SUBJECT: Forwards responses to questions raised re fire protection analysis.Diesel generator room drawings encl.

November 29, 1979
LDR-79-326

QUESTIONS AND ANSWERS CONCERNING
THE
DUANE ARNOLD ENERGY CENTER
FIRE HAZARD ANALYSIS

FOR INFORMATION ONLY
1007 - A8-111

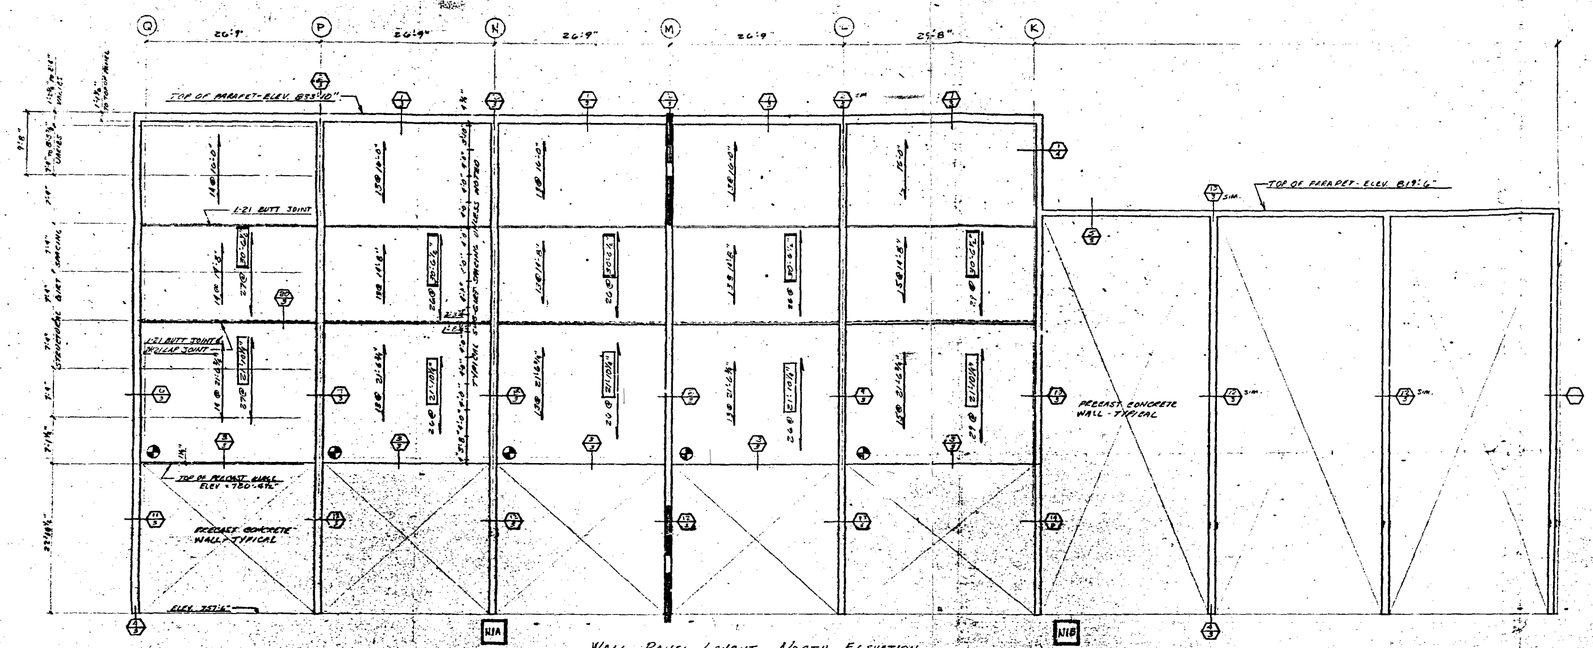
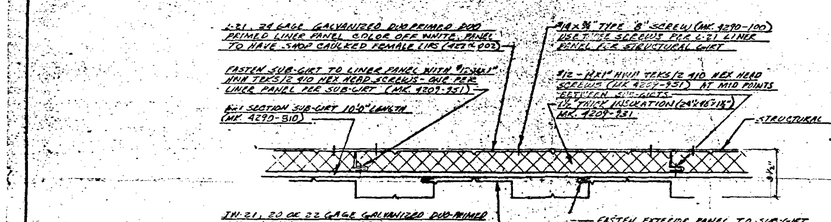
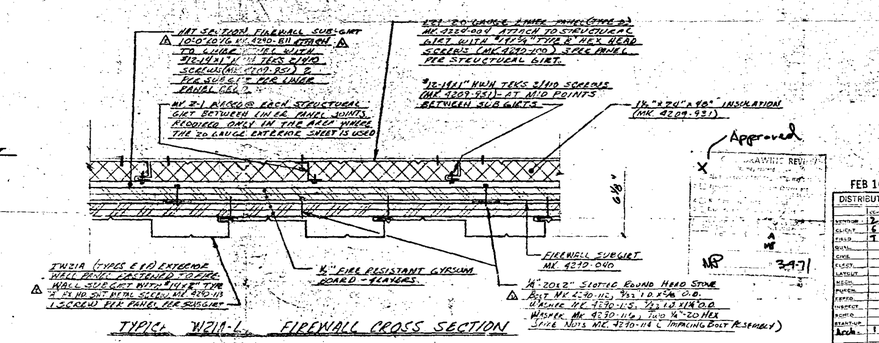
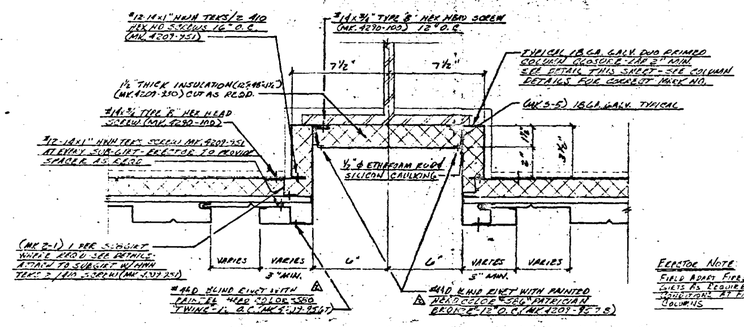
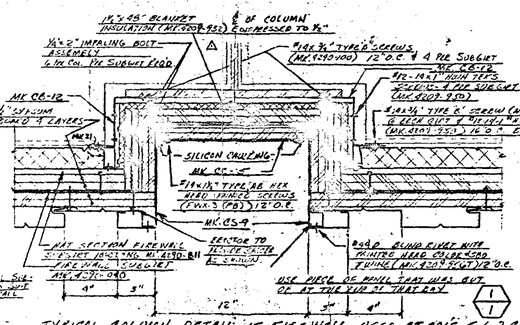
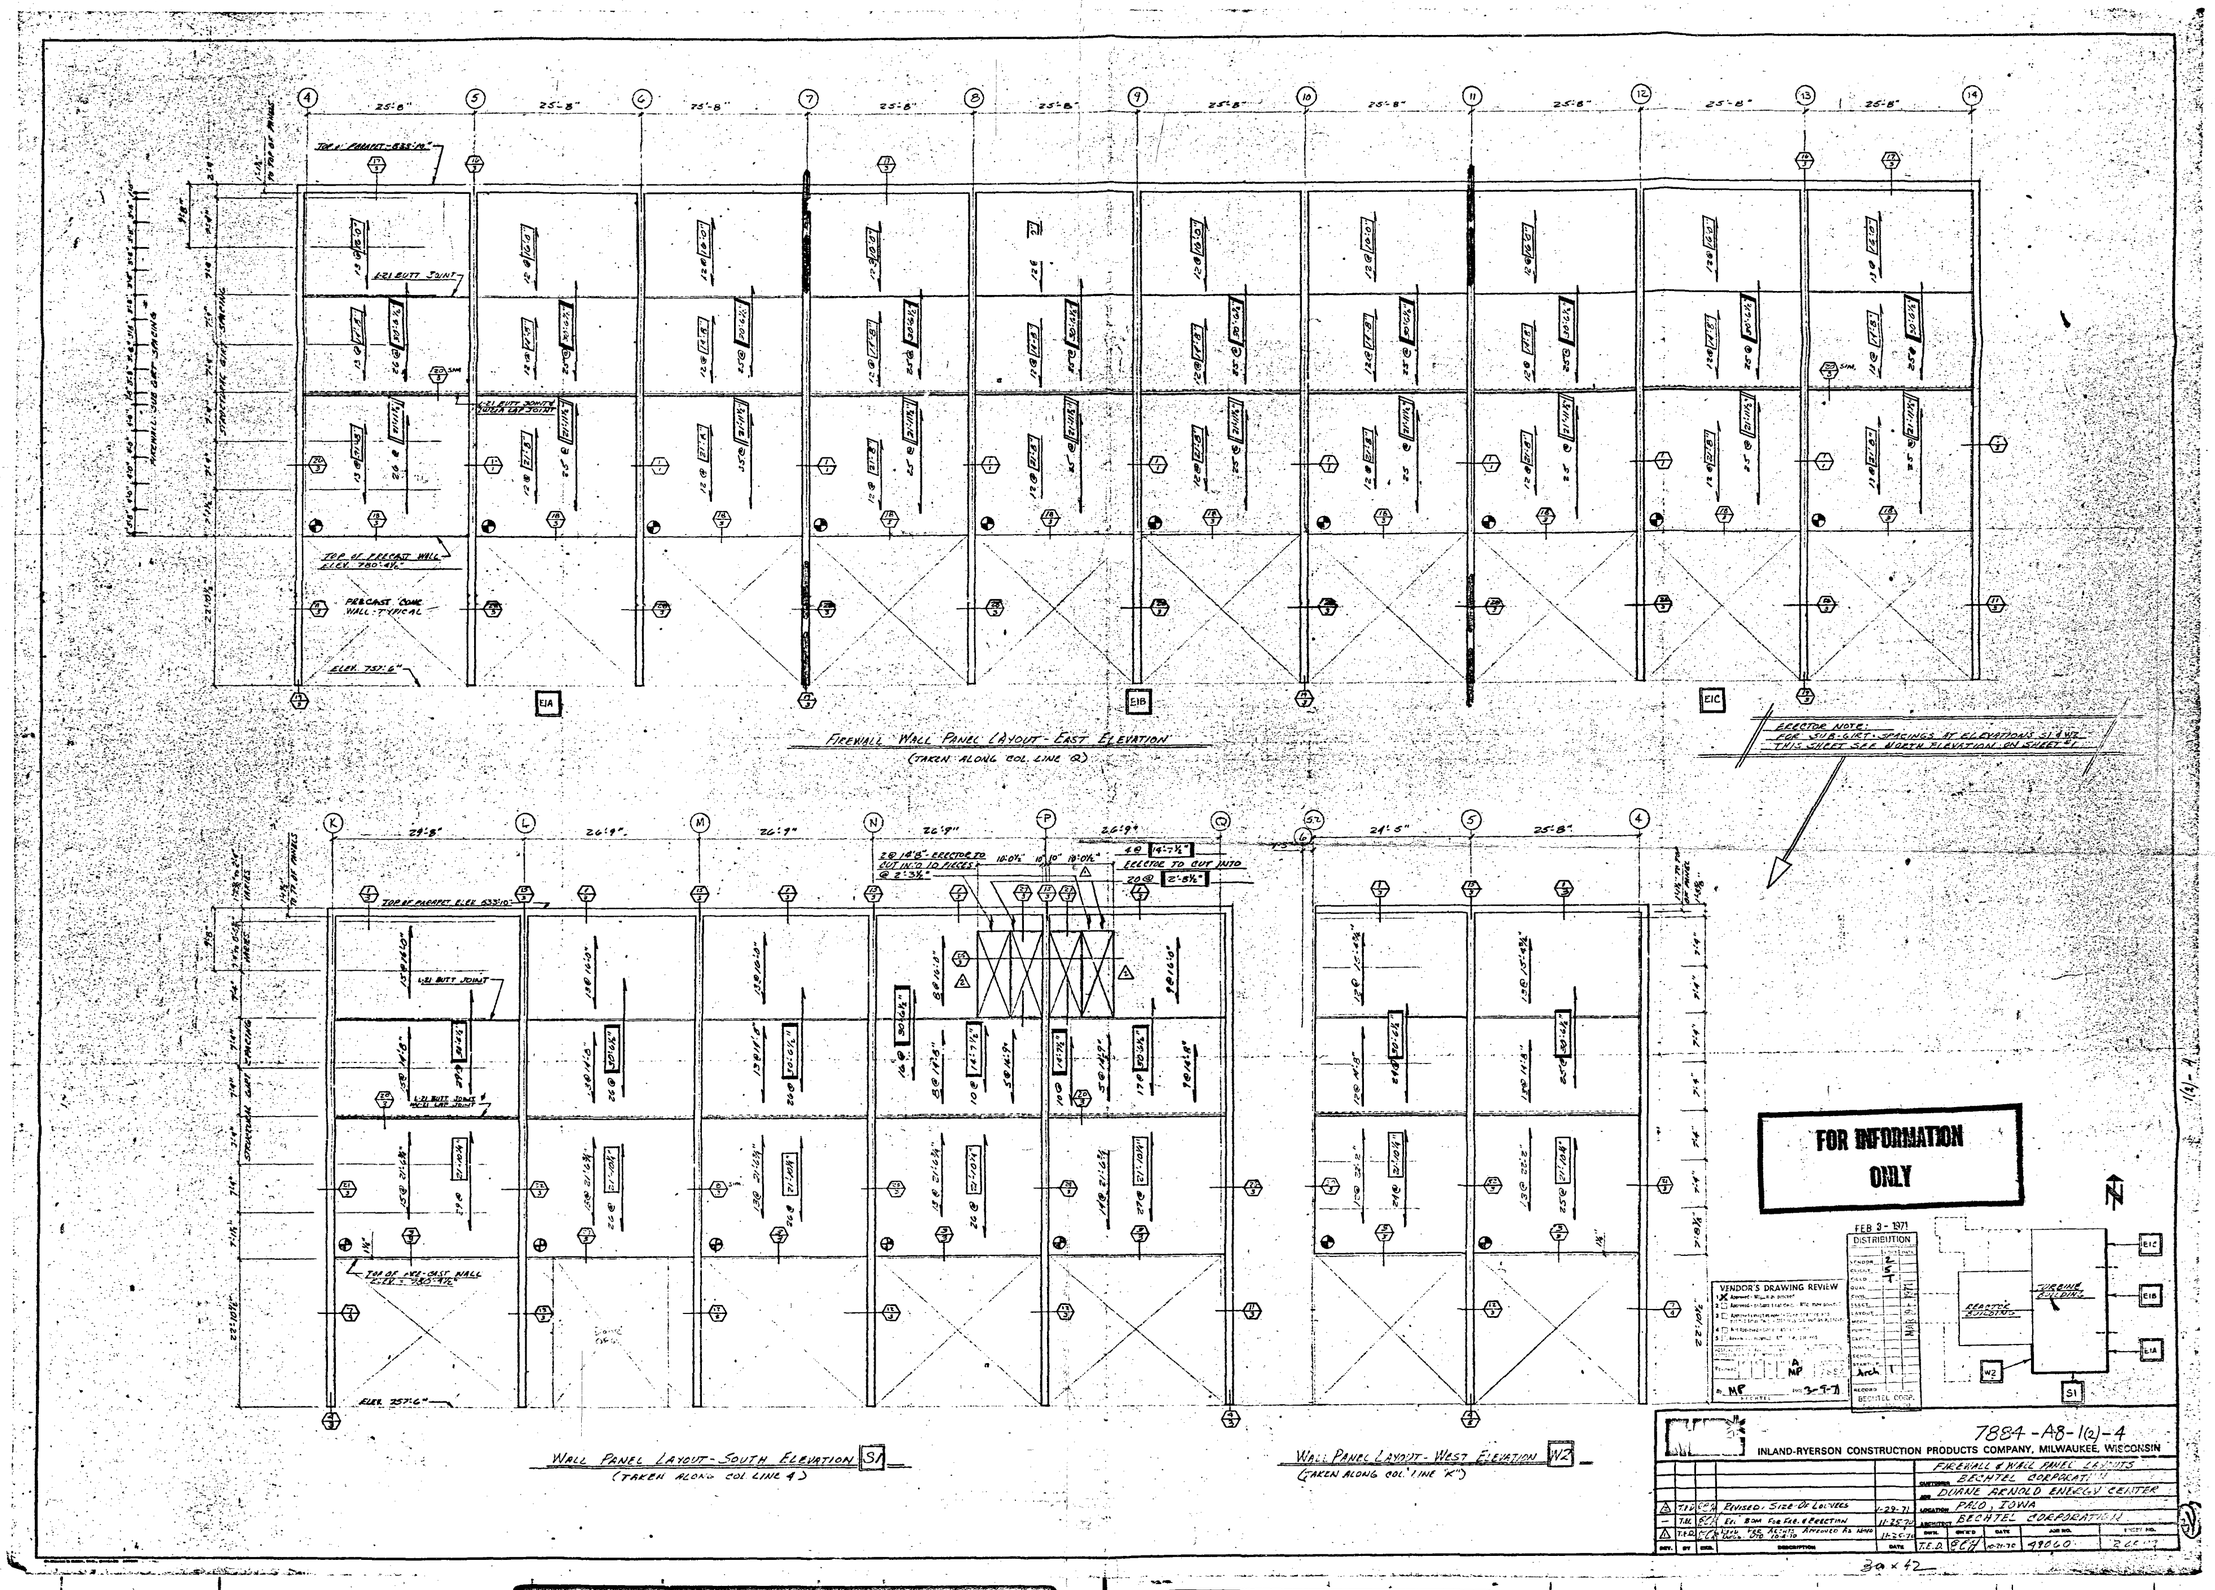
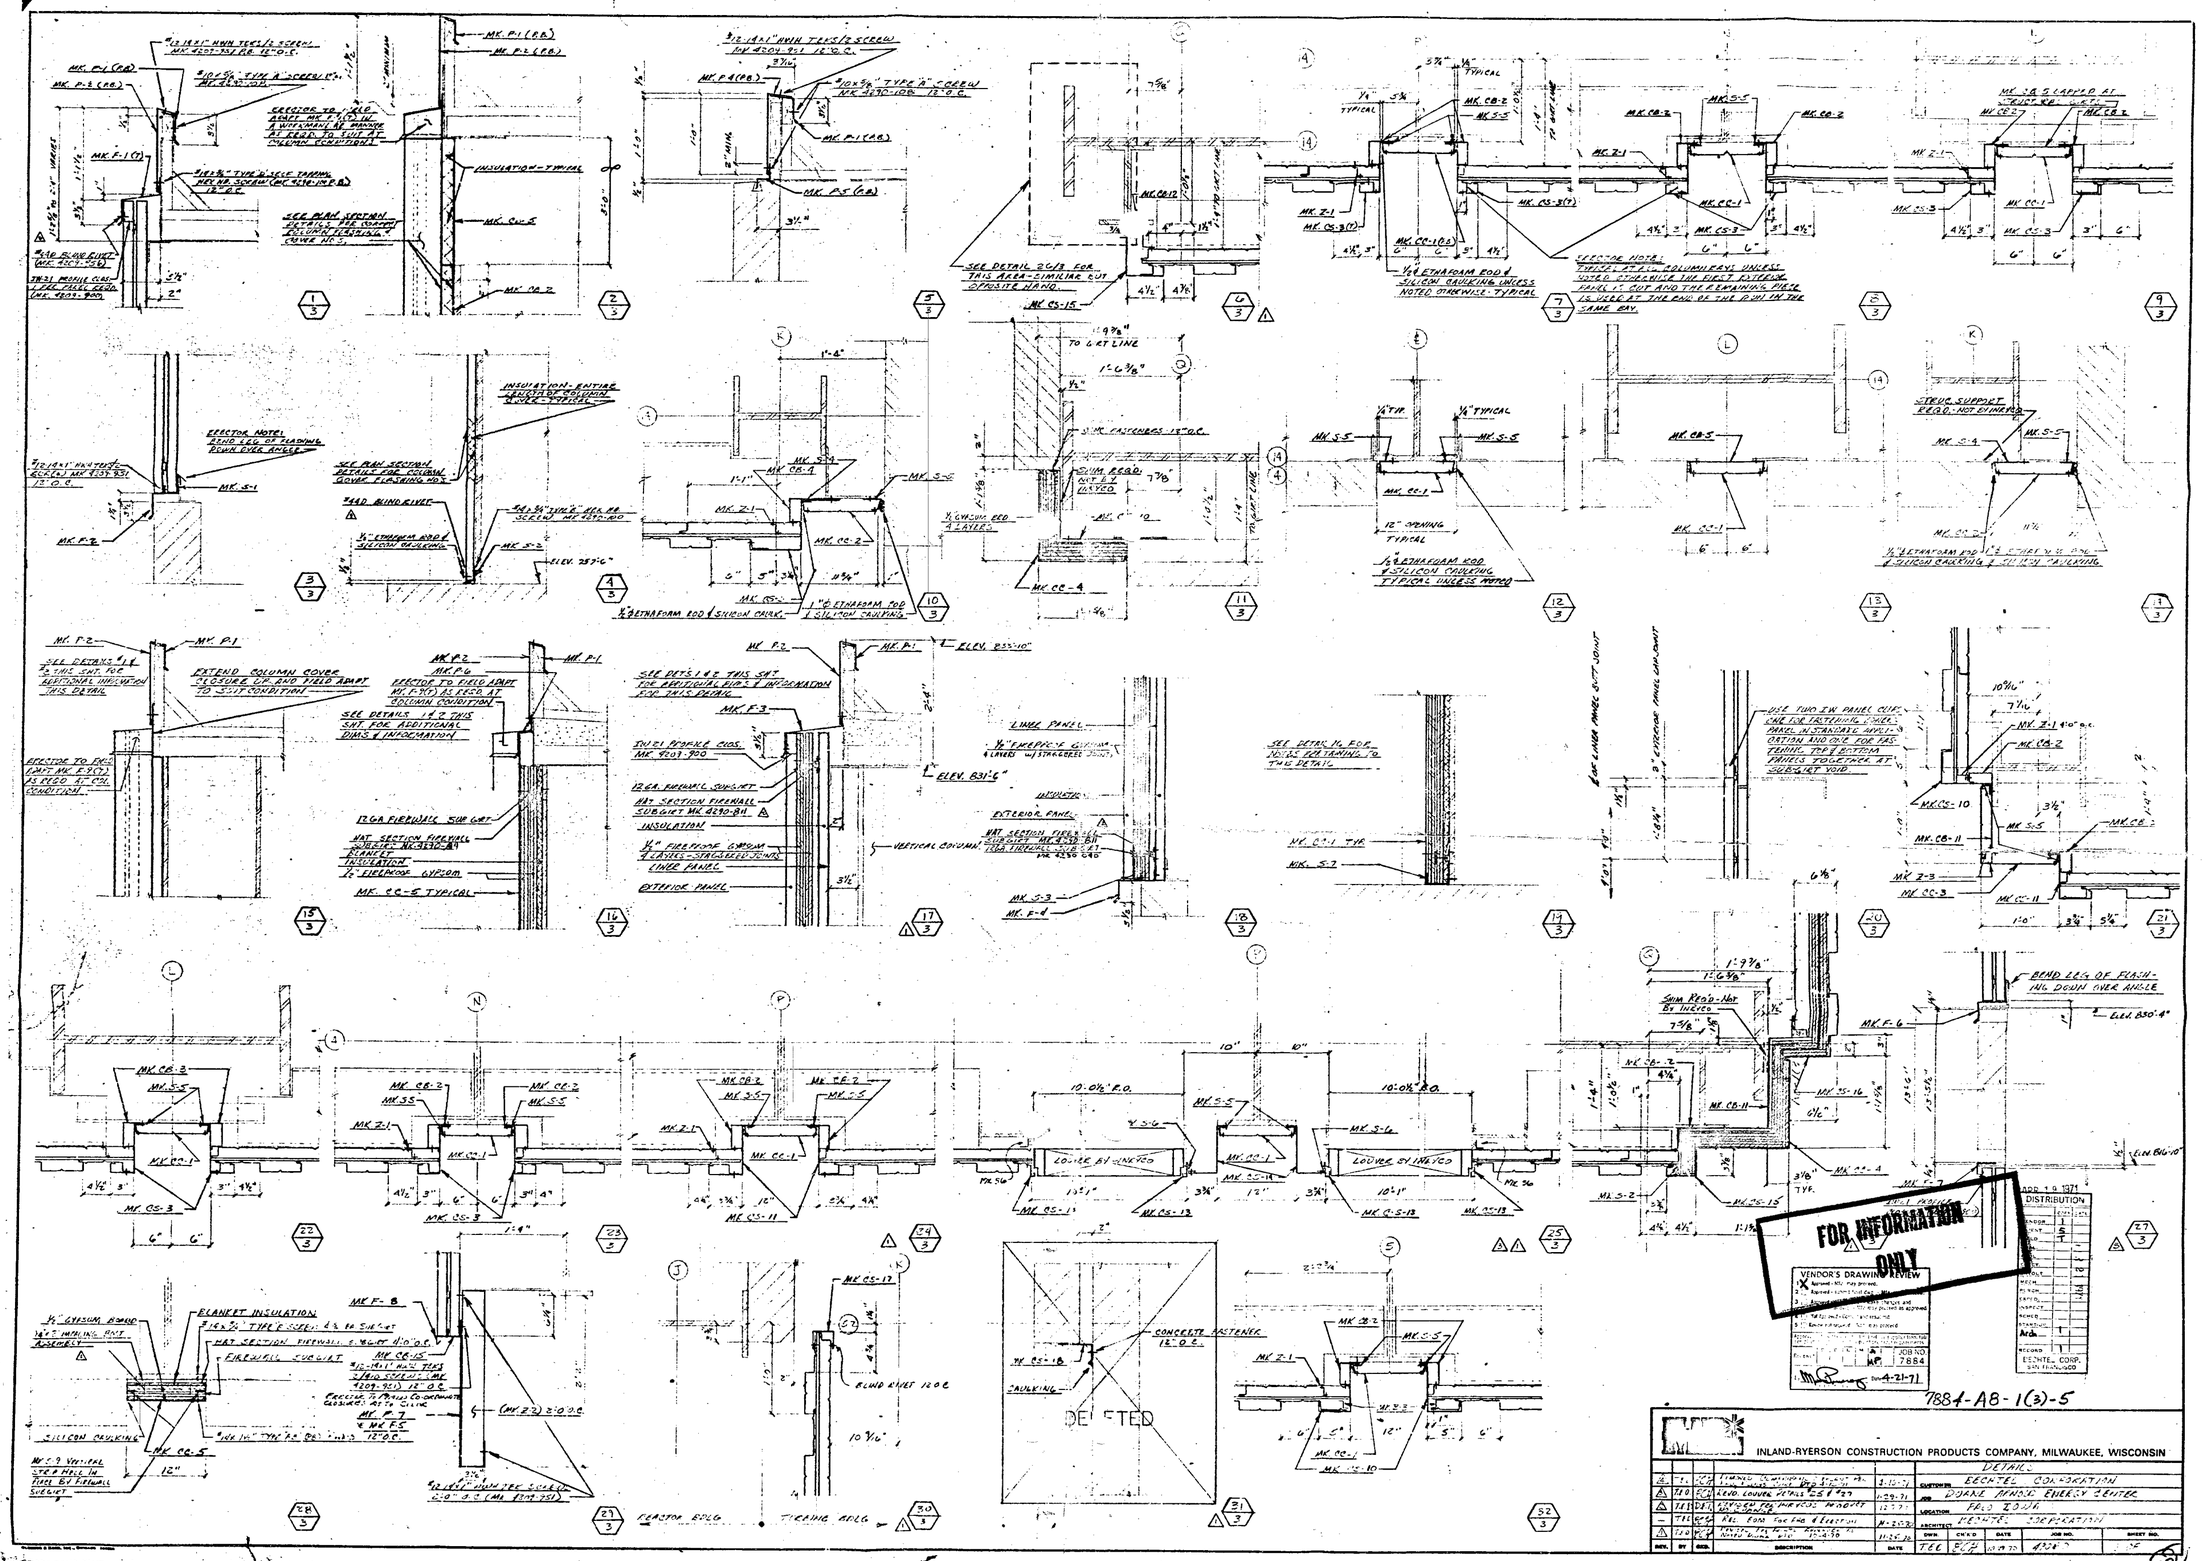
10. Between Zone 8B and external to the TB (east) there is a transformer next to the outside of the wall. With regard to the insulation, how is it secured, and what is its quality and thickness?

For the turbine building column insulation, refer to attached drawings A8-1(1), A8-1(2), A8-1(3).
